Response to DOM Referee

Howard Matis

December 3, 2008

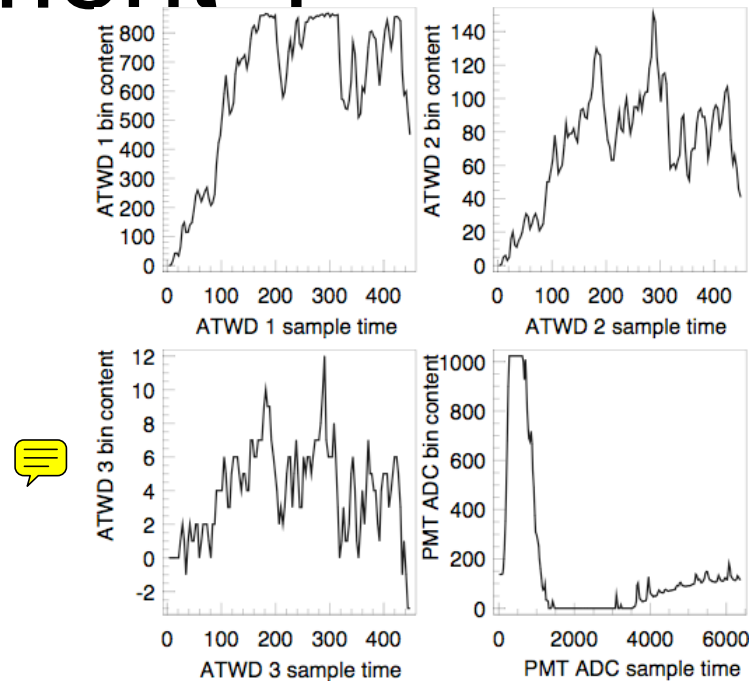
- In Fig.11, it seems to me that there are roughly 3 peaks in each ATWD waveform. Do the authors have any comments about the cause of these structures?

- Describe delayed photons, spread out in time because of ice scattering. reemphasize that data is correlated
